CONSTRUCTION PLANS FOR BOYCE PARK ACID MINE DRAINAGE REMEDIATION

RECORD DRAWINGS 10/07/08

**ACID MINE DRAINAGE
REMEDATION
PROJECT NO. ZCBP-AD01**

DRAINAGE STRUCTURE DETAIL

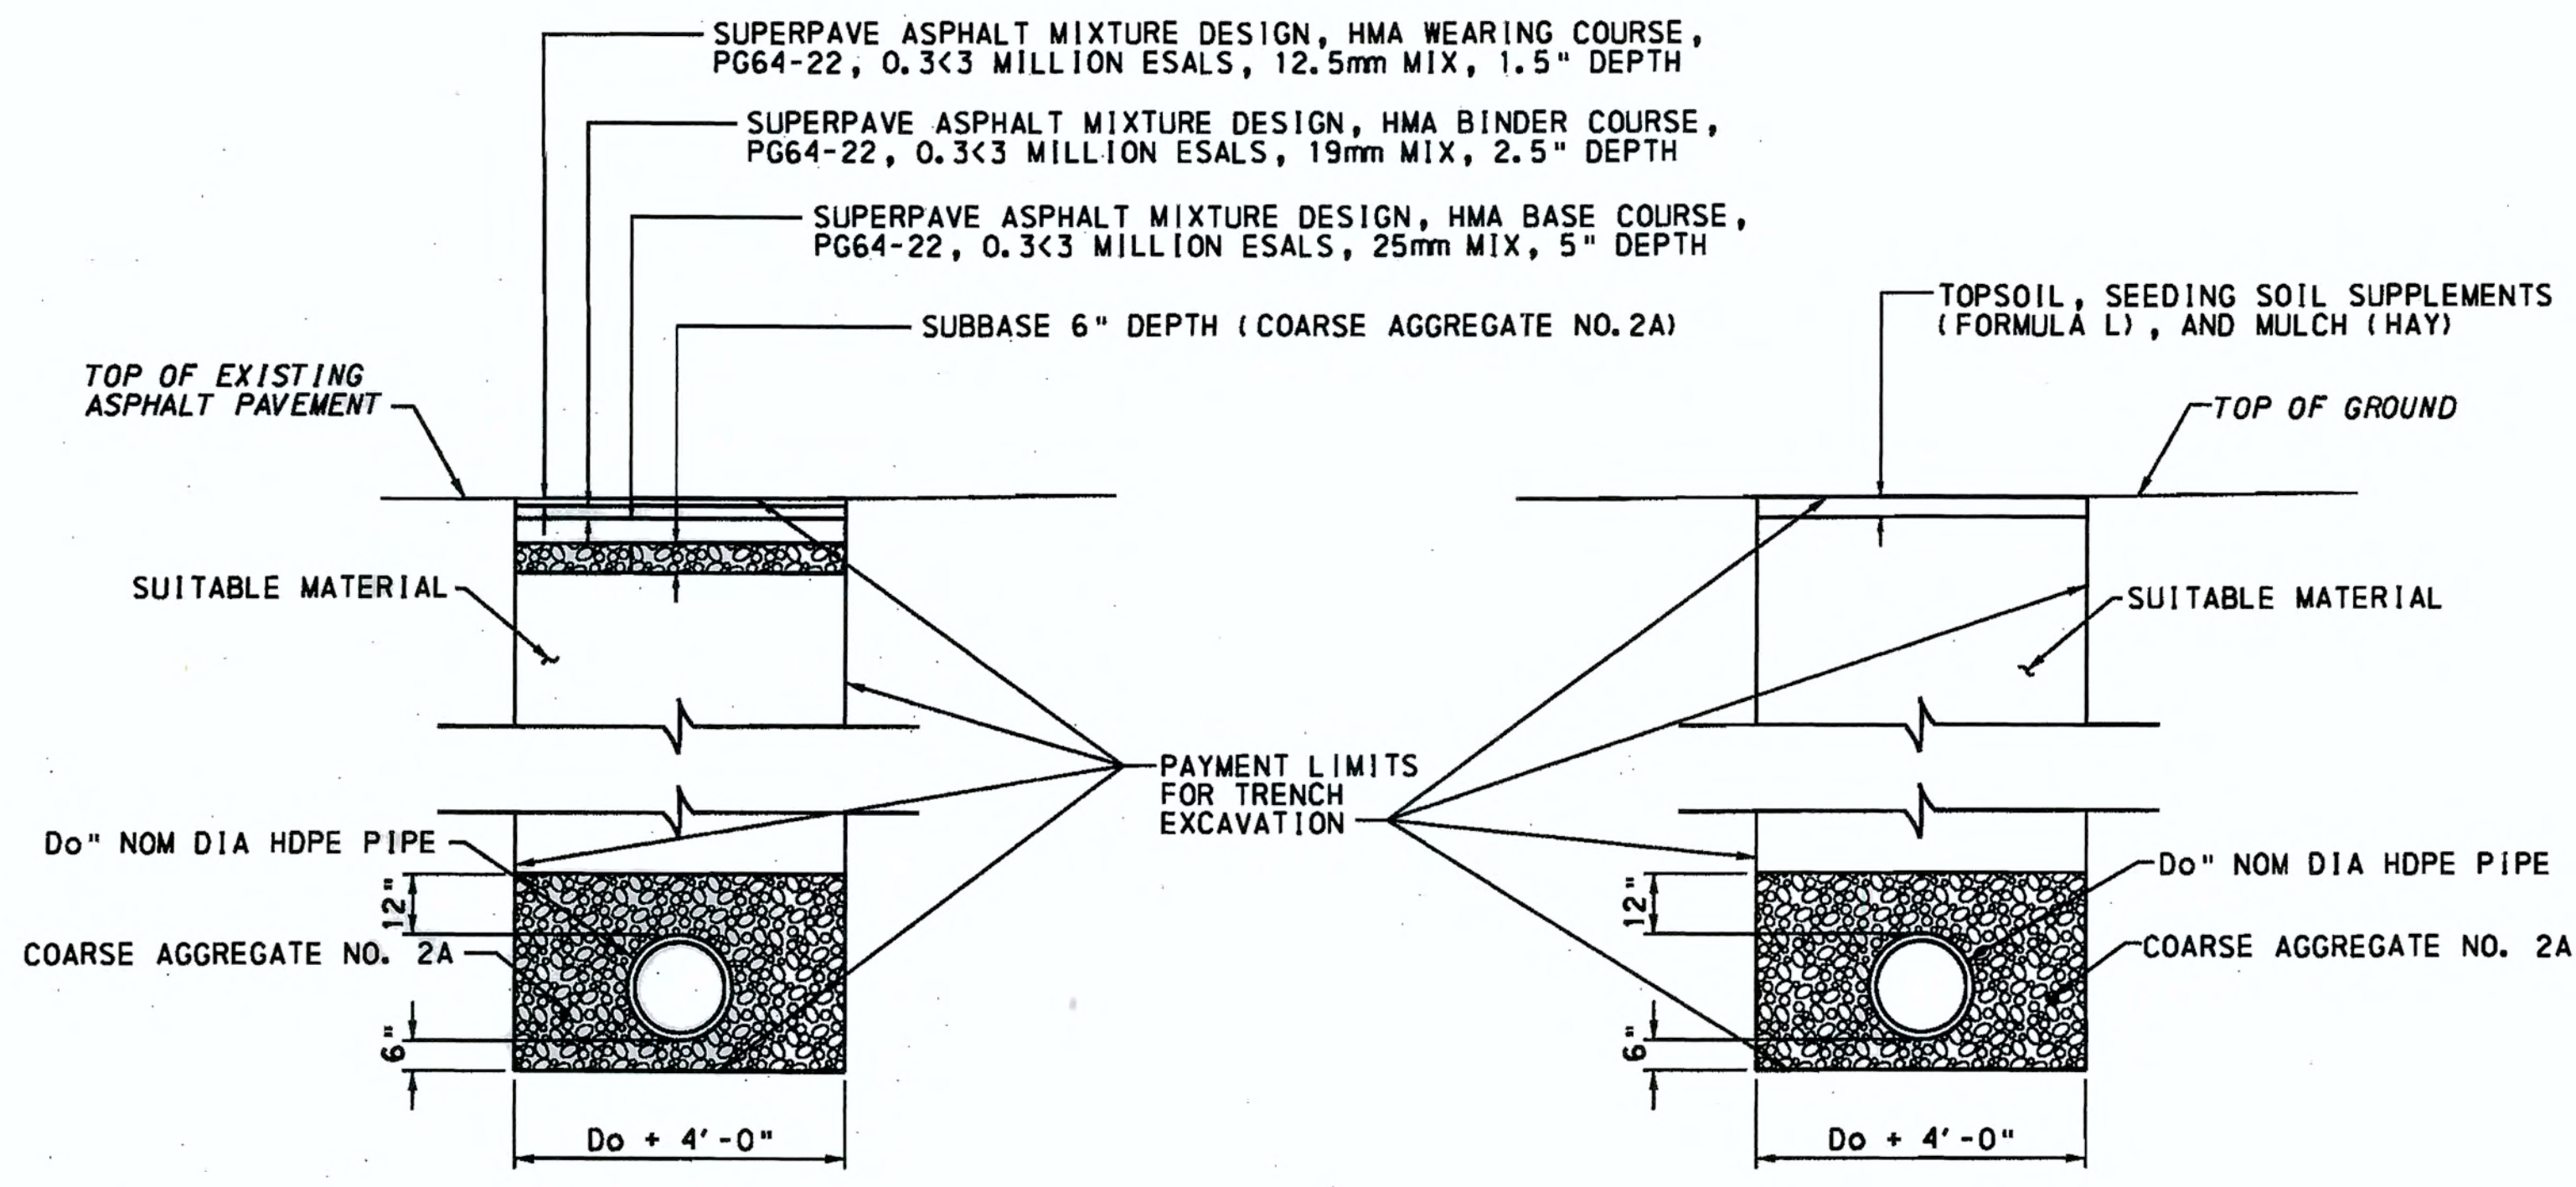
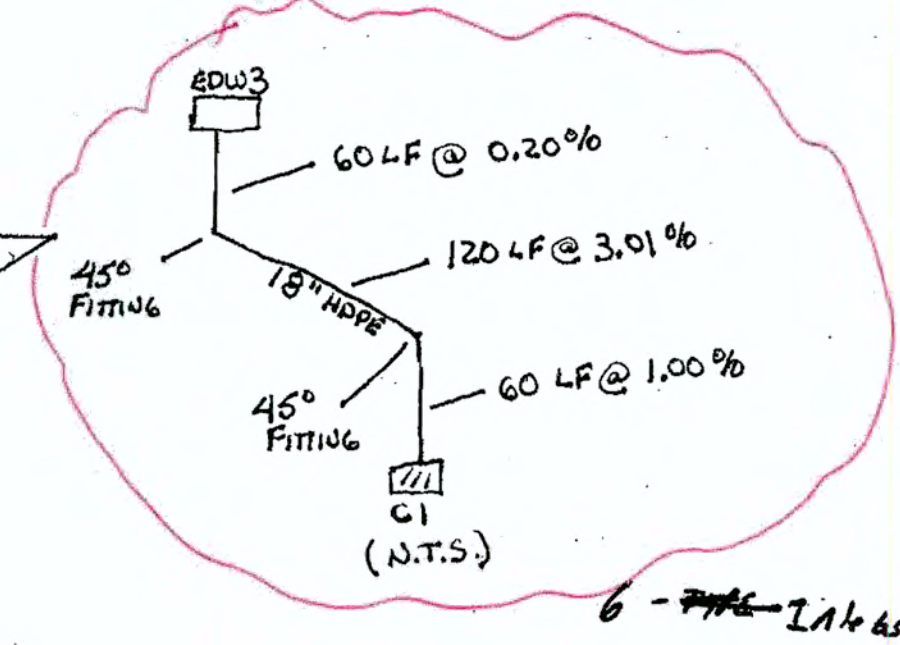
EDW1 N 5,020.64 E 9,711.31 ENDWALL TYPE D <i>Top 509.19</i> R-4 RIP RAP, L=10', W=5', THICKNESS=1.5' INV ELEV 506.50 TO A1 <i>506.50 TO B1</i> 175.00 L.F.=18" HDPE <i>175.00 L.F.=18" HDPE</i>	A1 N 4,887.64 E 9,595.03 EXISTING TG.=526.73 <i>same</i> INV ELEV 523.10 FROM EDW1 <i>same</i>
---	--

EDW2 N 4,977.28 E 9,753.03 ENDWALL TYPE D <i>Top 512.67</i> R-4 RIP RAP, L=10', W=10', THICKNESS=1.5' INV ELEV 509.80 TO B1 <i>509.79 TO B1</i> 145.78 L.F.=18" HDPE <i>145.00 L.F.=18" HDPE</i>	B1 N 4,834.06 E 9,777.19 TYPE M INLET TG = 525.80 <i>525.80</i> INV ELEV 521.00 FROM EDW2 <i>521.03</i>
--	--

EDW4 N 5147.44 E 9604.68 ENDWALL TYPE D <i>Top 509.33</i> R-4 RIP RAP, L=10', W=5', THICKNESS=1.5' INV ELEV 506.00 TO G1 <i>506.50 TO G1</i> 90.00 L.F.=18" HDPE <i>91 L.F.=18" HDPE</i>	G1 N 5079.96 E 9543.95 EXISTING INLET TG = 523.20 <i>same</i> INV ELEV 518.70 FROM EDW4 <i>518.65</i>
--	--

EDW3 N 4,979.68 E 9,756.70 ENDWALL TYPE D <i>Top 512.67</i> R-4 RIP RAP, L=10', W=10', THICKNESS=1.5' INV ELEV 509.80 TO C1 <i>509.79 TO C1</i> 217.37 L.F.=18" HDPE <i>240.00 L.F.=18"</i>	
---	--

C1 N 4,822.14 E 9,905.50 TYPE M INLET TG = 523.50 <i>523.40</i> <i>514.00</i> INV ELEV 514.02 FROM EDW3 INV ELEV 514.20 TO C2 <i>514.17</i> 36.27 L.F.=18" HDPE <i>37.00 L.F.</i>
--

C2 N 4,828.86 E 9,944.71 TYPE M INLET TG = 522.60 <i>522.55</i> INV ELEV 514.82 FROM C1 <i>514.83</i> INV ELEV 515.00 TO C3 <i>515.00</i> 58.22 L.F.=18" HDPE <i>58.00 L.F.</i> INV ELEV 518.80 TO C7 <i>515.00</i> 20.00 L.F.=18" HDPE <i>19.00 L.F.</i>
--

C3 N 4,842.04 E 10,005.21 TYPE S INLET TG = 522.50 <i>522.50</i> INV ELEV 516.12 FROM C2 <i>516.14</i> INV ELEV 516.30 TO C4 <i>516.31</i> 62.25 L.F.=18" HDPE <i>62.00 L.F.</i> INV ELEV 516.60 TO D1 <i>516.30</i> 38.35 L.F.=18" HDPE <i>36.50 L.F.</i>

C4 N 4,857.85 E 10,069.35 TYPE M INLET TG = 523.00 <i>523.00</i> INV ELEV 517.42 FROM C3 <i>517.31</i> INV ELEV 517.60 TO C5 <i>517.64</i> 132.88 L.F.=18" HDPE <i>132.50 L.F.</i>

C5 N 4,874.25 E 10,205.25 TYPE M INLET TG = 525.00 <i>525.00</i> INV ELEV 520.82 FROM C4 <i>520.71</i> INV ELEV 521.00 TO C6 <i>520.89</i> 123.10 L.F.=18" HDPE <i>122.50 L.F.</i> INV ELEV 521.00 TO E1 <i>521.07</i> 20.00 L.F.=18" HDPE <i>19.50 L.F.</i>

C6 N 4,871.88 E 10,332.37 EXISTING INLET TG = 527.80 <i>same</i> INV ELEV 523.52 FROM C5 <i>same</i> INV ELEV 523.70 TO F1 <i>same</i> 29.00 L.F.=18" HDPE <i>28.00 L.F.</i>

ADDITIONAL
B1 to EXISTING
Top EXISTING 525.80
INVERT IN 521.17
INVERT OUT - EXISTING C B
522.30
